Please substitute these replacement drawings for the drawings now on file in the above-identified patent application.

**Amendment After Allowance under 37 CFR 1.312**

FIG. 1

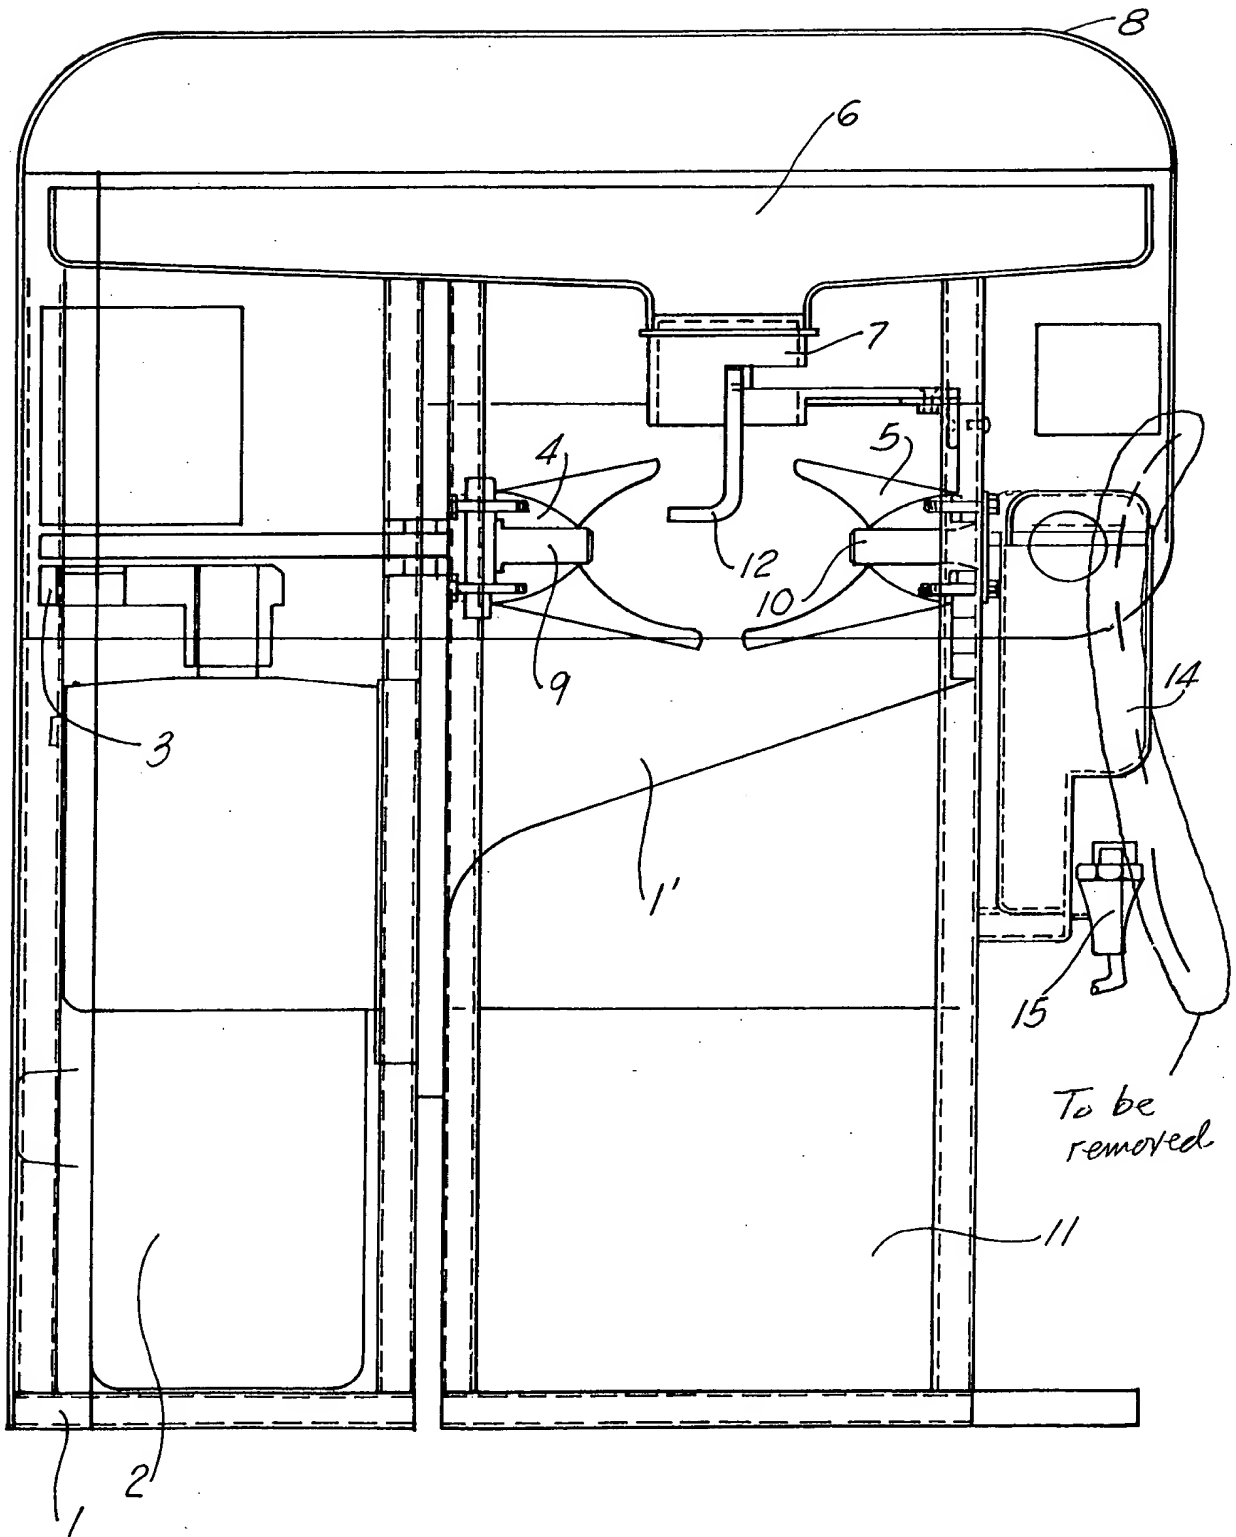
Specifically regarding FIG. 1, a curved pattern of dashed lines, not mentioned in the application and apparently inadvertently provided in the original FIG. 1, has been removed. An annotated sheet with this is provided in which the curved pattern of dashed lines is encircled.

FIG. 3

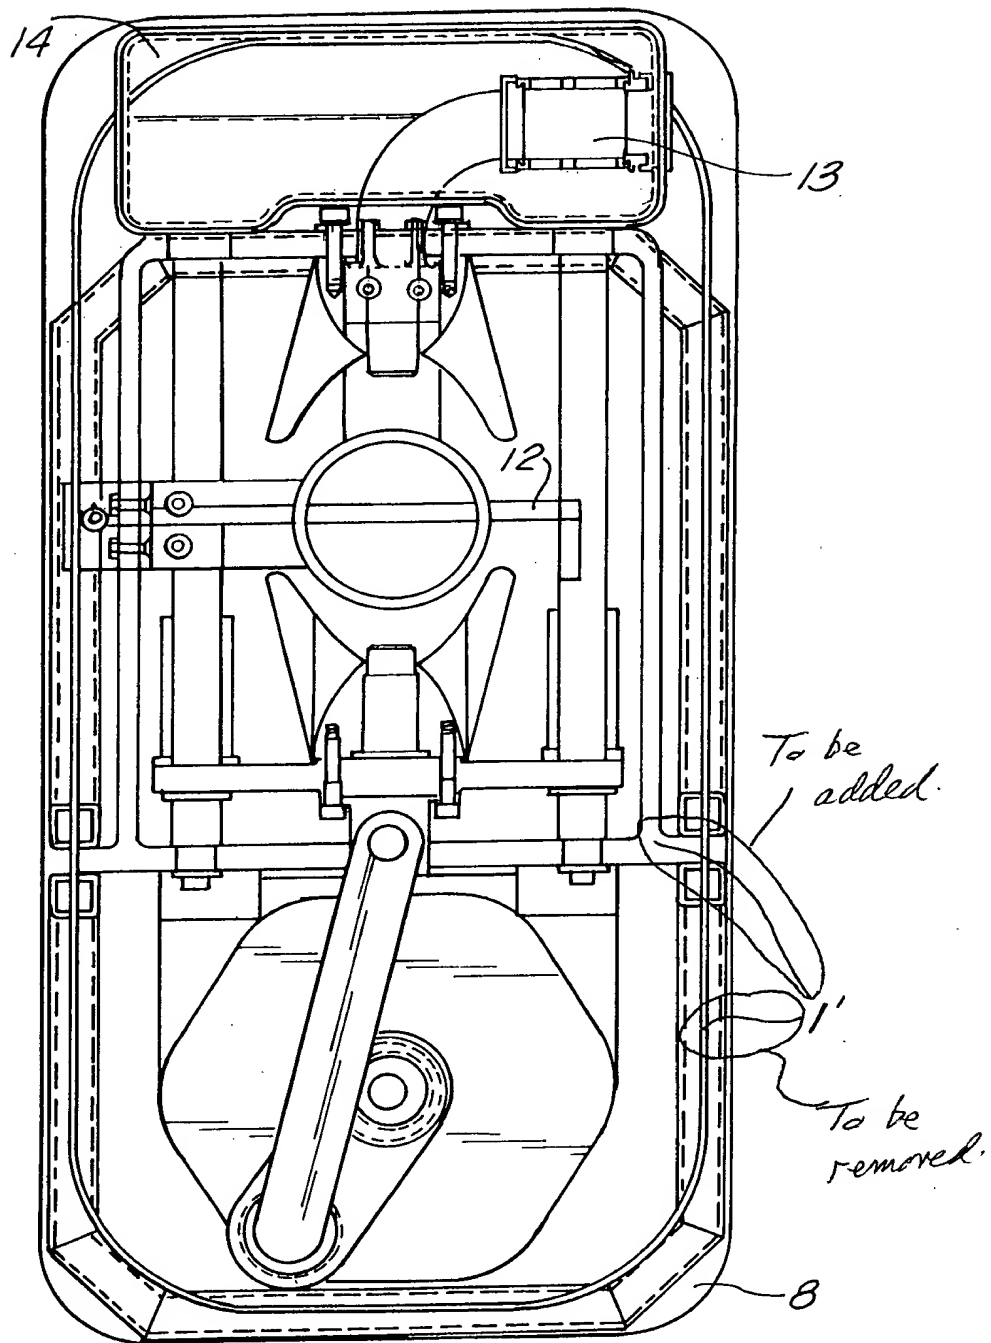
Specifically regarding FIG. 3, the lead line for 1' is corrected, as it was inadvertently leading to the wrong element. An annotated sheet with this is provided in which the old and the new lead lines are encircled. Support for this correction is found in FIGs. 1 and 2, and also in the specification, page 11, lines 3-11, which identify "... a tubular chassis 1, affixed to an extraction box 1' ...".
